Outer Dowsing Offshore Wind

Offshore Reactive Compensation Platform Physical Processes Assessment Clarification Notes

Document Reference: 27.7

2 ORCP Physical Processes Clarification Note 1 dated 19th May 2025

Figure 4 The distances between the JNCC boundary of the IDRBNR SAC components and the Project survey location to the ORCP area and ORCP restriction area.

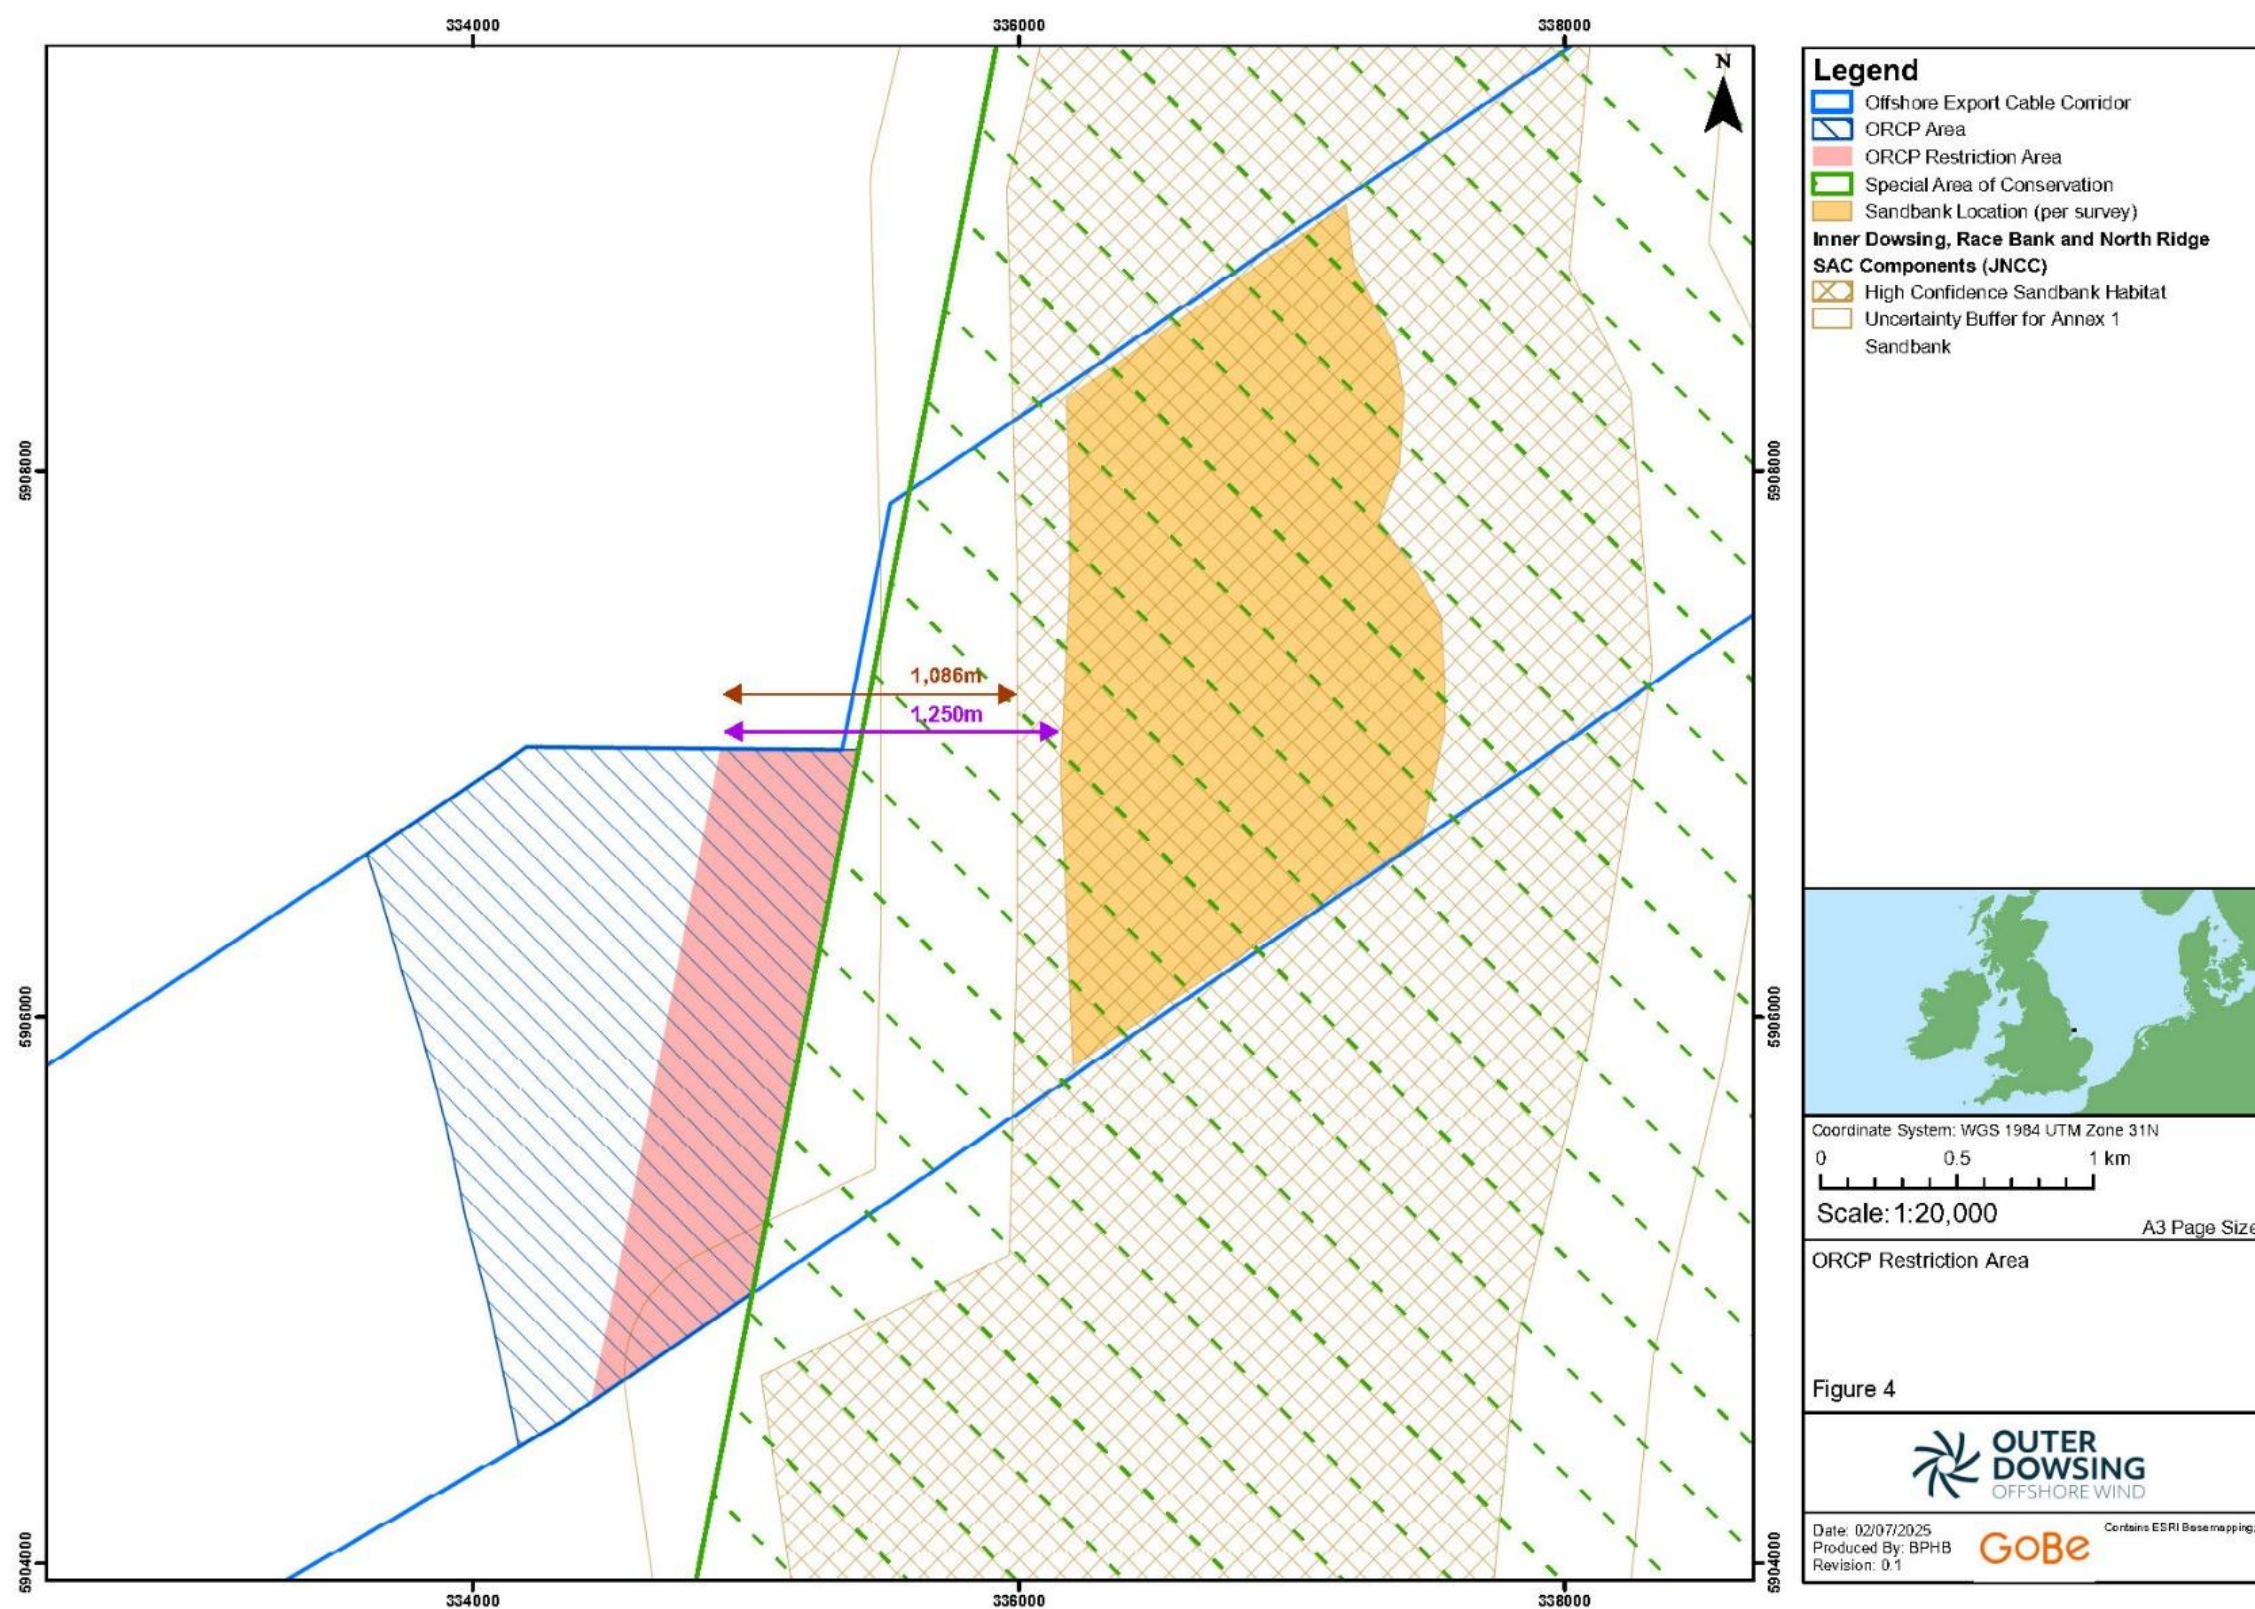
- That further consideration needs to be given to the potential effect of sandbank migration (due to evidence of sandbank migration provided in the Seabed Mobility Study (APP-152)) and resulting interactions between the ORCP structures and the migrating sandbank-sandwave system.

- 24 Notwithstanding the information presented in the preceding paragraphs, the Applicant has acknowledged Natural England concerns and proposed an ORCP restriction area of 500m between the ORCP(s) and the IDRBNR SAC. As presented in Figure 4, the restriction area/buffer inherently includes the following distances:

- 1,086m between the ORCP(s) and the High Confidence Sandbank Habitat area defined by JNCC (2019); and
 - 1,250m between the ORCP(s) and the sandbank location, as defined by survey results from GEOxyz. (2022c)

- 25 Therefore, the ORCP Restriction Area allows for the potential migration² of the sandbank from these locations over a possible extended operation period³, defined, using the maximum migration rate⁴, as 840m. When the medium migration rate of 7.5m/yr is applied (which is based on comparison of data collected at the site as opposed to regionally), the total sandbank migration is predicted as 360m over the extended operational lifetime. This migration, if it were to occur, would not exceed the westward boundary of the ORCP Restriction Area, meaning that it is unlikely there would be any interaction between the sandbank and the ORCP.
